SOLICITATION ADDENDUM NO. 2
ITB 19-0036
Terra Linda Re-Pipe and Restroom Remodel

Note: The drawing set was issued to Washington County for building permit approval on 1/6/2020. Plan check comments were received and responded to as "Delta 1" on 2/10/2020. The plan check response sheets are included as part of this package.

TERRA LINDA ELEMENTARY SCHOOL RE-PIPE AND RESTROOM REMODEL

Sheet
P2.2

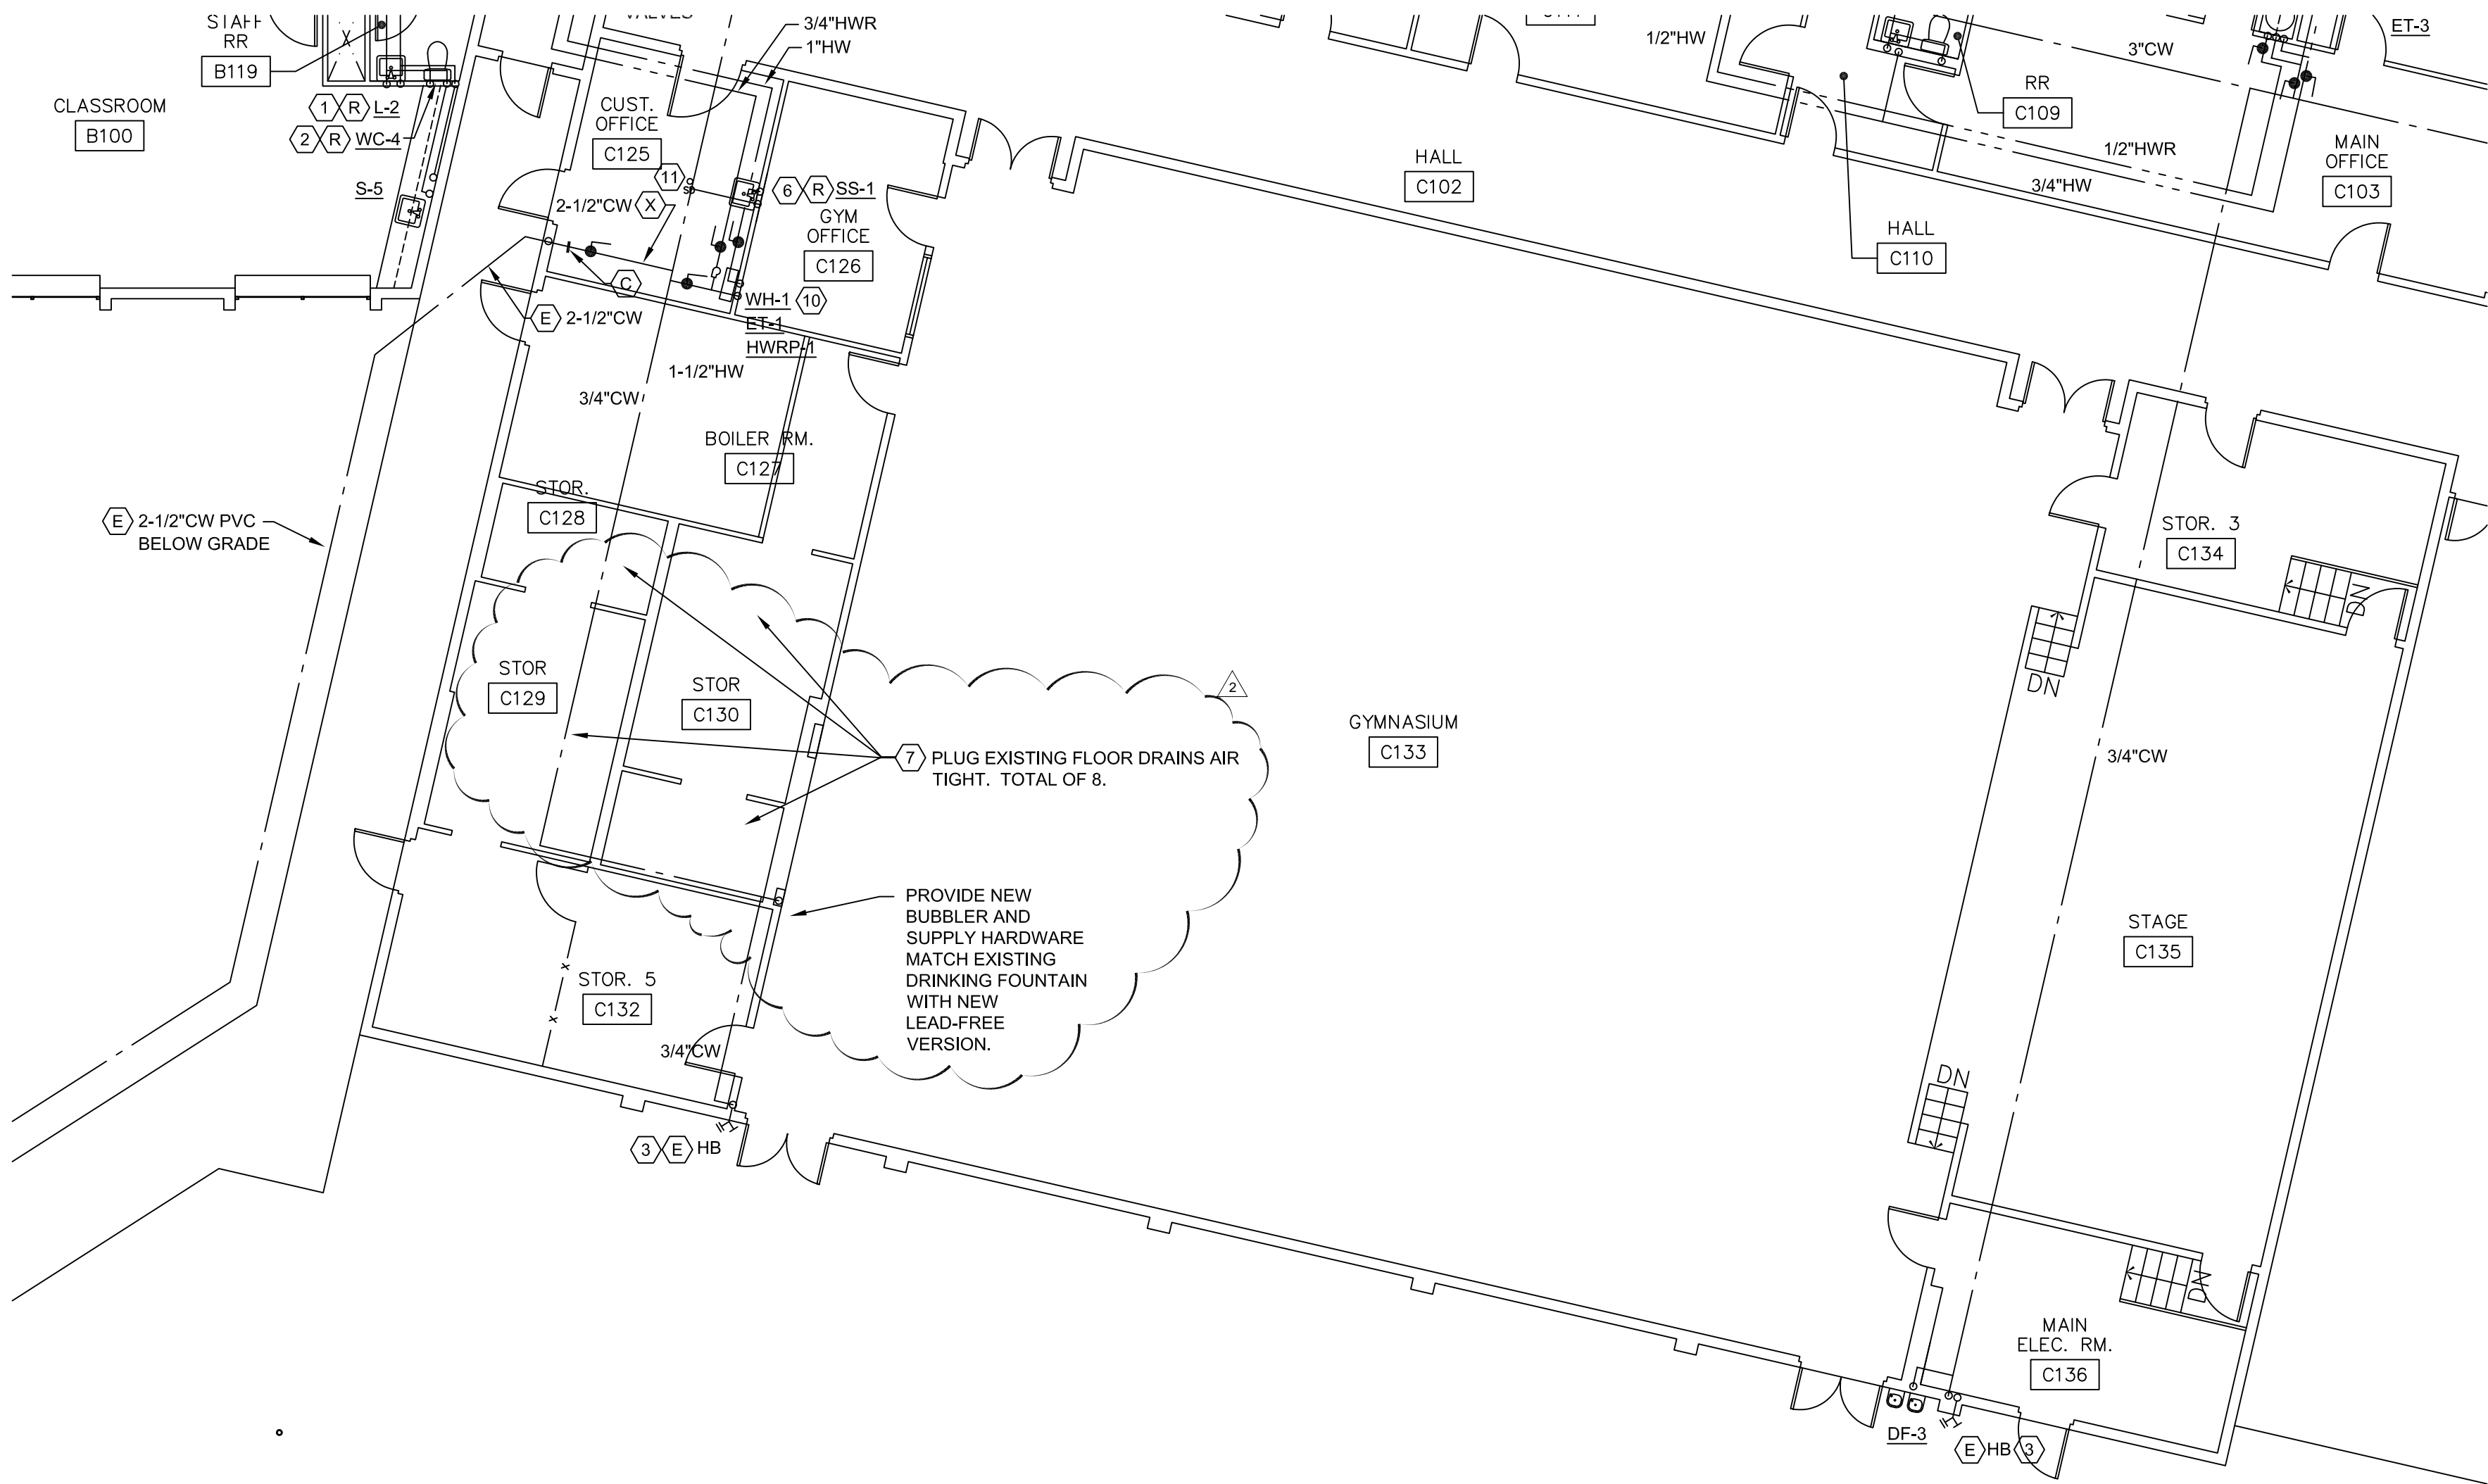
Question: What is the scope for the can wash?
Answer: Replace can wash valve with model specified in updated Specifications. Replace supplies to valve. (Language is to be provided in specifications - see Specifications section below, and on Sheet P2.2 – see Drawings section below)

Question: What scope for Electrical bonding to water line?
Answer: Reconnect all existing electrical bonding to new water lines. (Language is to be provided on Sheet P2.2 – see Drawings section below)

1 PLUMBING FLOOR PLAN
P2.3 1/8" = 1'-0"

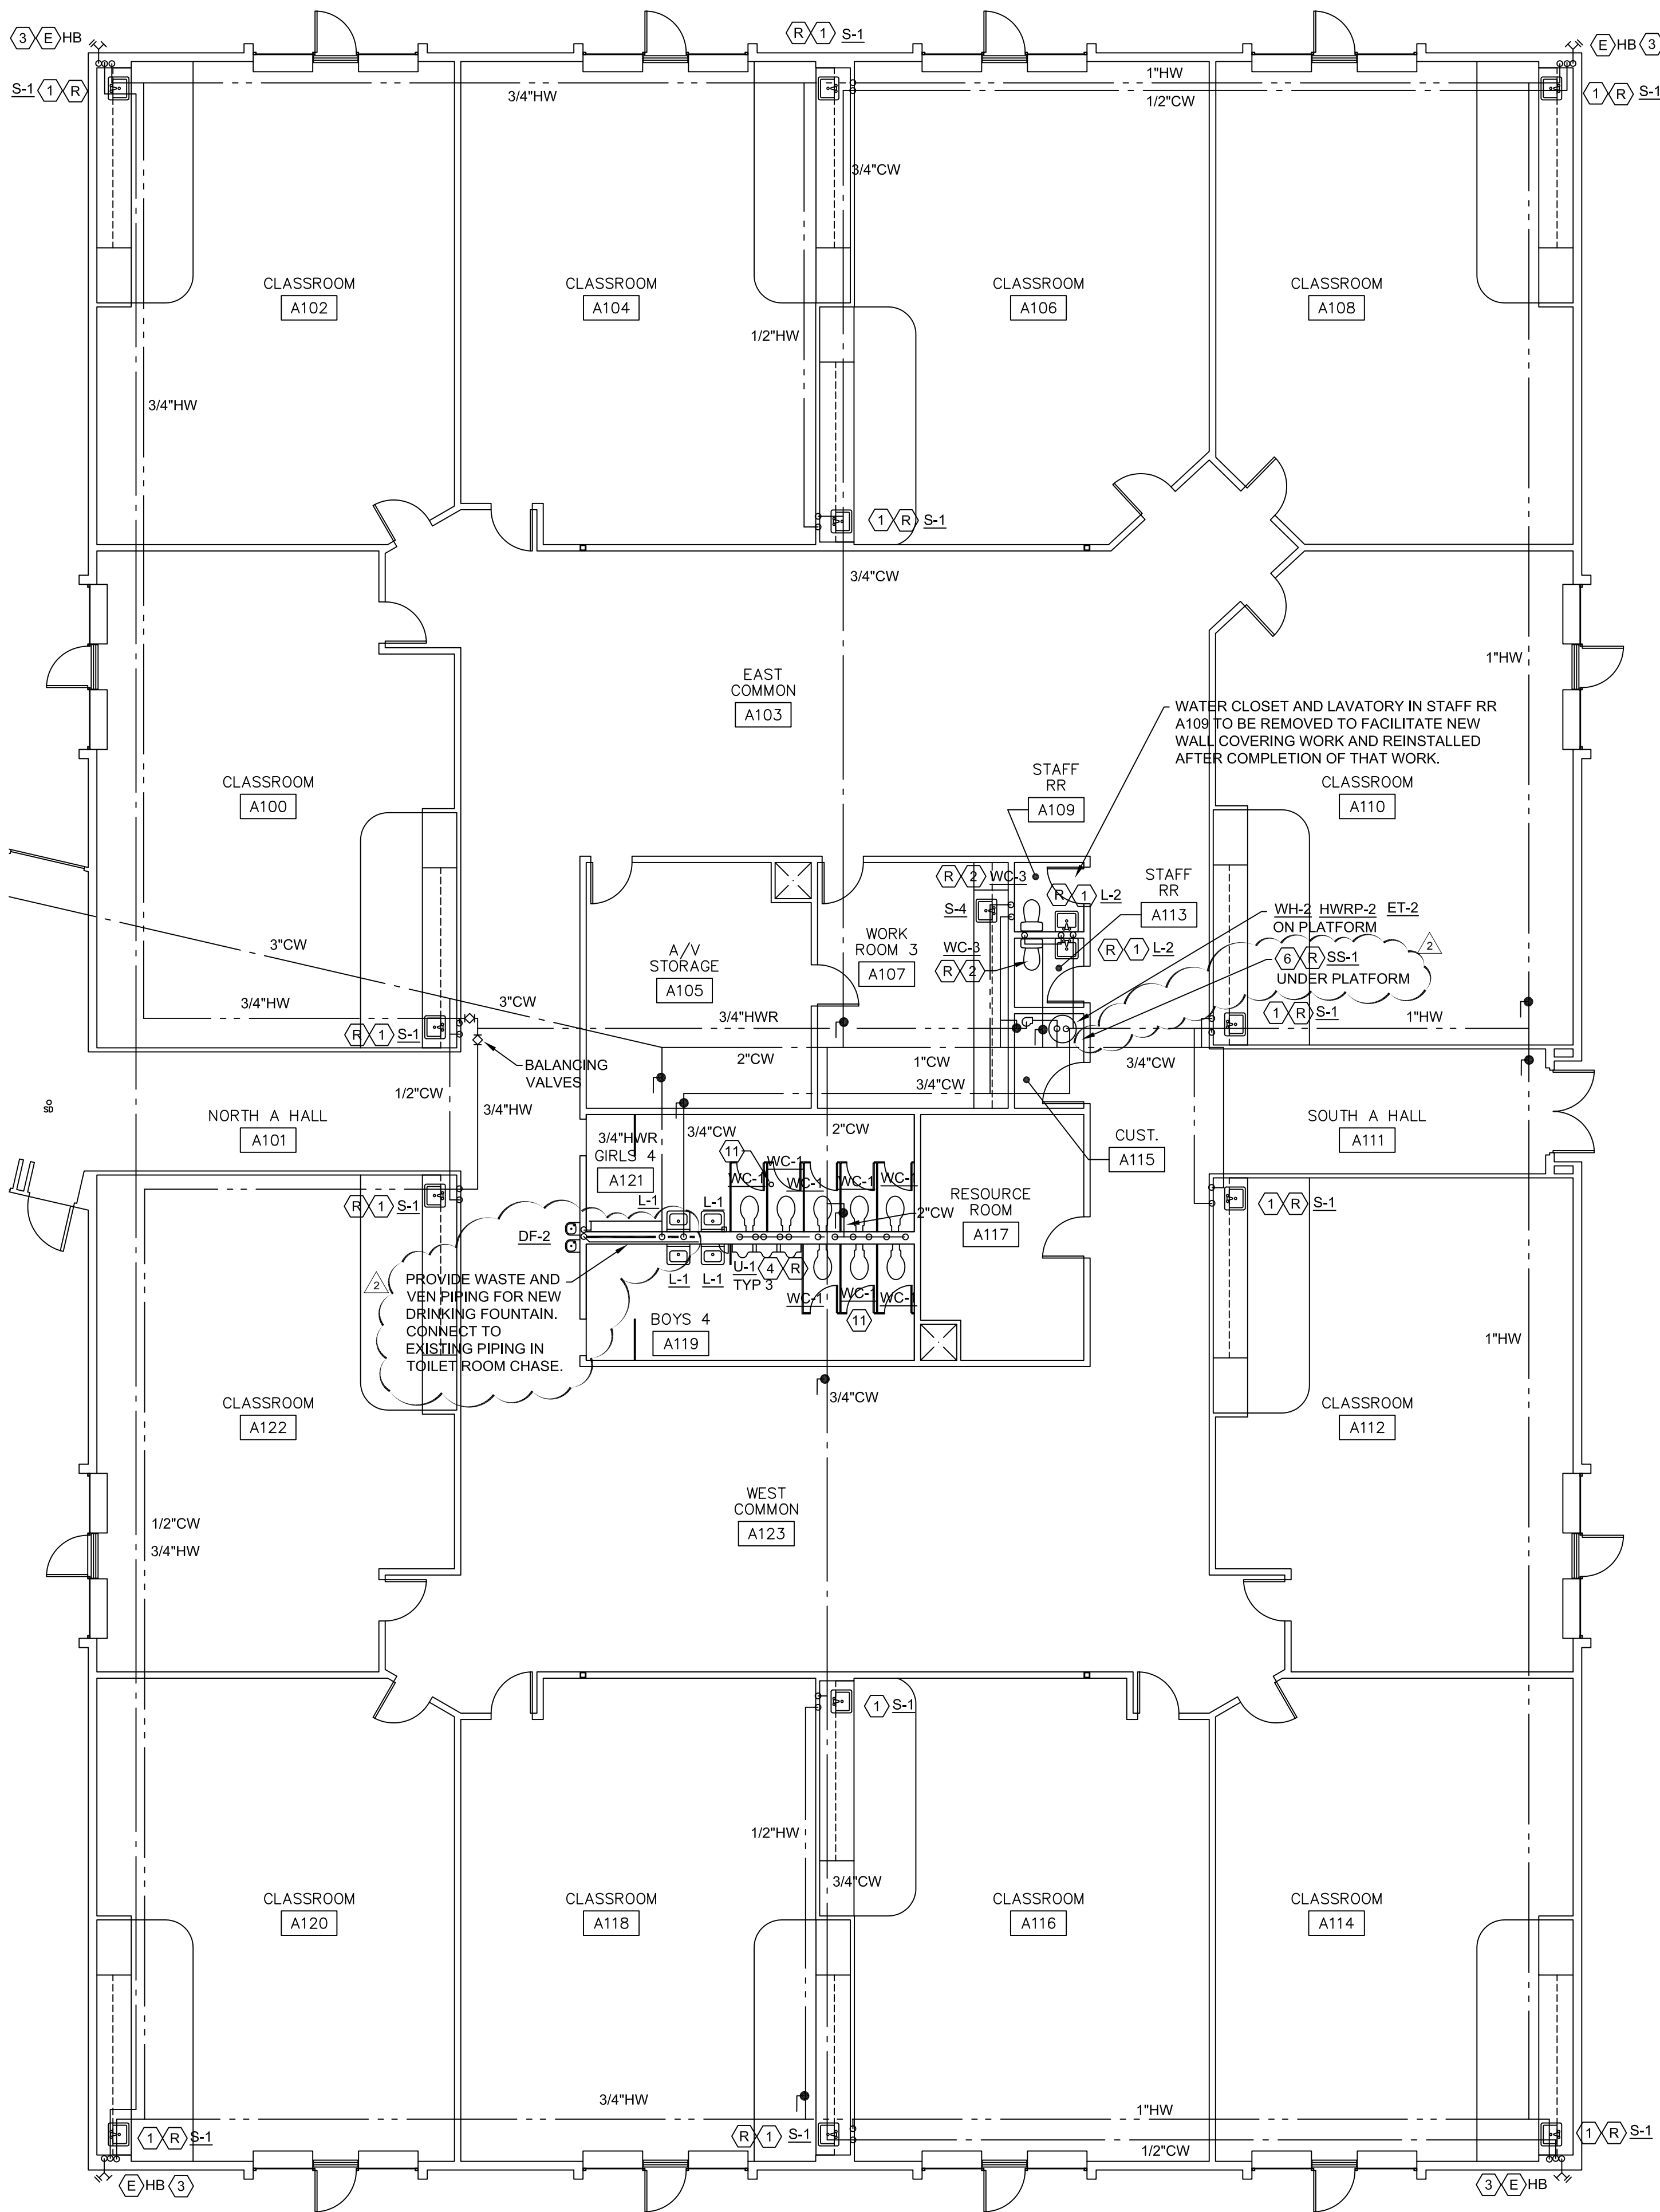
Question: Please provide specs for bubbler in gym.
Answer: Match existing drinking fountain hardware with new lead-free version. (Language is to be provided on Sheets P2.3 – see Drawings section below)
